April 2019
1690010952

Leviathan Gas Platform

Emission Permit Review

Figure 1. Cumulative distribution of annual NOx emissions for offshore platforms in the Gulf of Mexico.

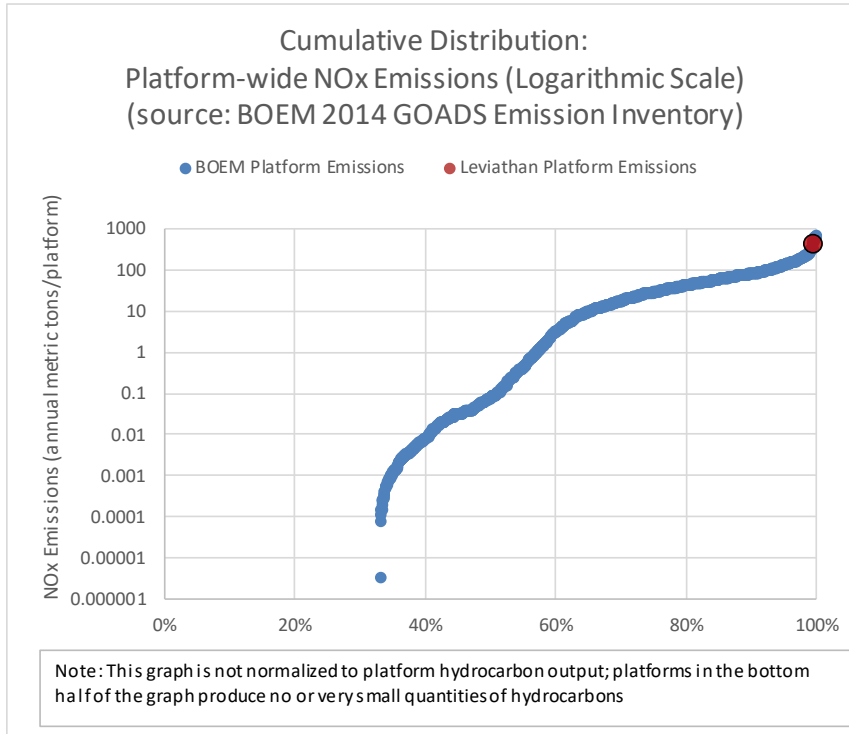
Figure 1 suggests that the Leviathan platform would be near the very highest percentile for NO_x emissions, similar to the less than 5% of the highest-emitting platforms in the Gulf of Mexico. By comparison, Figure 2 suggests that approximately 30% of platforms in the Gulf of Mexico would have higher VOC emissions than the Leviathan platform.

This suggests that NO_x emissions from the Leviathan platform, as described in the request for emission permit, are similar to the largest, highest-emitting platforms in the U.S. Gulf of Mexico development area. Similarly, VOC emissions are comparable to the largest 30% of platforms in the Gulf of Mexico. Based on discussions with BOEM, the VOC emissions from the 70% of platforms below those of the Leviathan platform in the GOADS database are from platforms with very little gas production or that are otherwise out of operation or idled⁹. This suggests that for a high gas production platform such as the Leviathan platform, much larger VOC emissions would be expected than those described in the request for emission permit. Some of the comments made in section 2.1 above, if addressed properly in the request for emission permit, would lead to an increase in the VOC emission inventory for the proposed platform. We also note that the control system proposed here is novel and its operation has not been demonstrated for such a large scale operation. As noted above, close monitoring of this system is strongly recommended, particularly in the initial phase of operation of the platform, to ensure that the control efficiency as described in the request for emission permit is actually achieved.
